Subject: Exelon Nuclear Texas Holdings, LLC
Victoria County Station Early Site Permit Application
Hydrology Audit Information Needs Response
NRC Docket No. 52-042

In response to the NRC information needs requests identified during the NRC Hydrology Audit conducted on November 30, 2010 and December 1, 2010, Exelon is providing responses to the following NRC Information Needs (INH) Items:

Information Needs Item No. 8:**NRC Request:**

Figure 1. Elevation-storage relationships for Coletto Creek Dam based on SSAR Tables 2.4.3-10 and -11

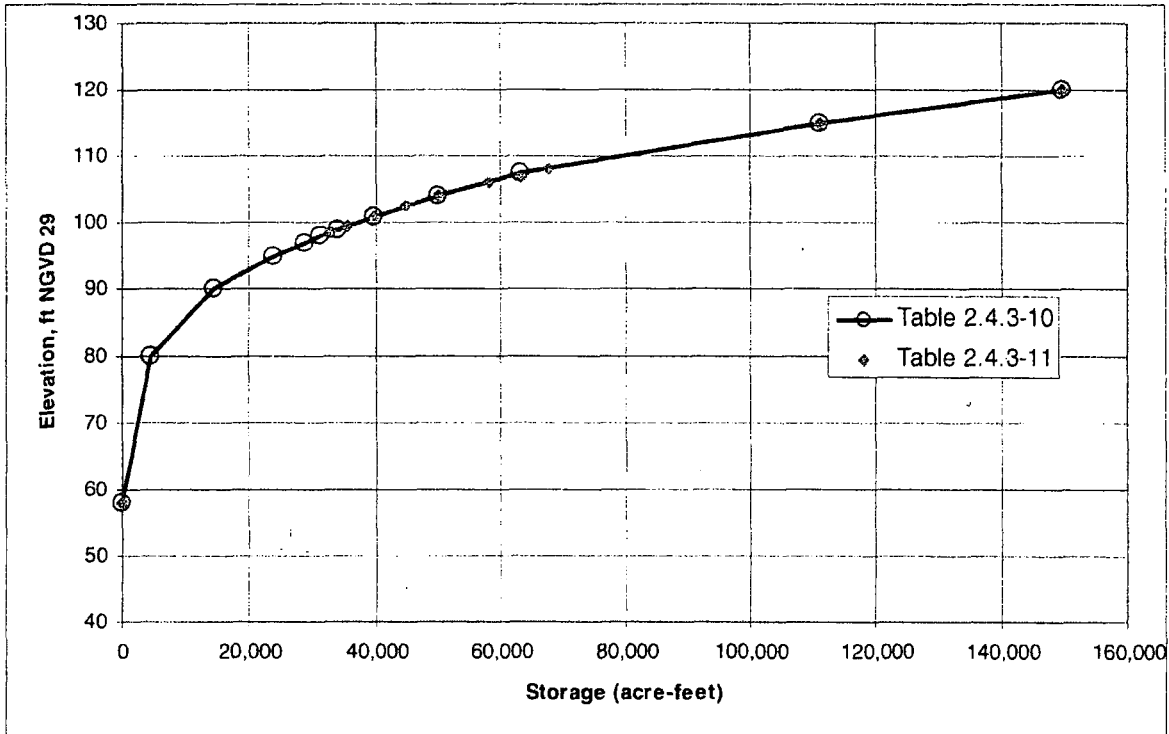
In the meeting, NRC also asked that clarifications be provided on two items: (a) an apparent discrepancy of about 10 percent in the Coletto Creek Dam/Reservoir elevation-storage relationships shown in SSAR Rev 0, Tables 2.4.3-10 and Table 2.4.3-11, and (b) the statements "*The elevation-storage relationships for the Coletto Creek Dam are slightly different from those given in Subsections 2.4.1 and 2.4.4. Since the impact due to these differences is expected to be minor, they are adopted in the VCS PMF model as given in the NWS RFS model.*" in SSAR Rev 0, Subsection 2.4.3.3, page 2.4.3-7.

As described in SSAR Rev 0 Subsection 2.4.3.3.1, the elevation-storage and storage-discharge relationships for the Coletto Creek Dam/Reservoir used in the PMF analysis for the Victoria County Station (VCS) site, as shown in the corresponding Tables 2.4.3-10 and 2.4.3-11, are adopted from the National Weather Service (NWS), River Forecast System (RFS) for Guadalupe River Basin (Reference 2.4.3-2). SSAR Table 2.4.3-10 listed the storage values for specific elevations from 58 to 120 feet NGVD 29 as given in Reference 2.4.3-2. SSAR Table 2.4.3-11, however, focuses primarily on storages above elevation 98.5 feet NGVD 29, which is the starting water level for the Coletto Creek Dam in the VCS PMF analysis (see SSAR Table 2.4.3-25). The additional elevation-storage values provided in Table 2.4.3-11 from elevation 98.5 to 108 feet NGVD 29 were derived by interpolation of the relationship in Table 2.4.3-10. The two elevation-storage relationships are compared graphically in Figure 1, which illustrates that there is no discrepancy in the elevation range of significance to the PMF analysis (above 98.5 feet NGVD 29).

As a result of the clarification to Item (a), the footnote for SSAR Rev 0, Table 2.4.3-11 will be revised as follows:

Source: U.S. National Weather Service River Forecast System for Guadalupe River Basin (Reference 2.4.3-2), with storage values interpolated from Table 2.4.3-10 (for elevations 98.5 feet NGVD 29 and higher).
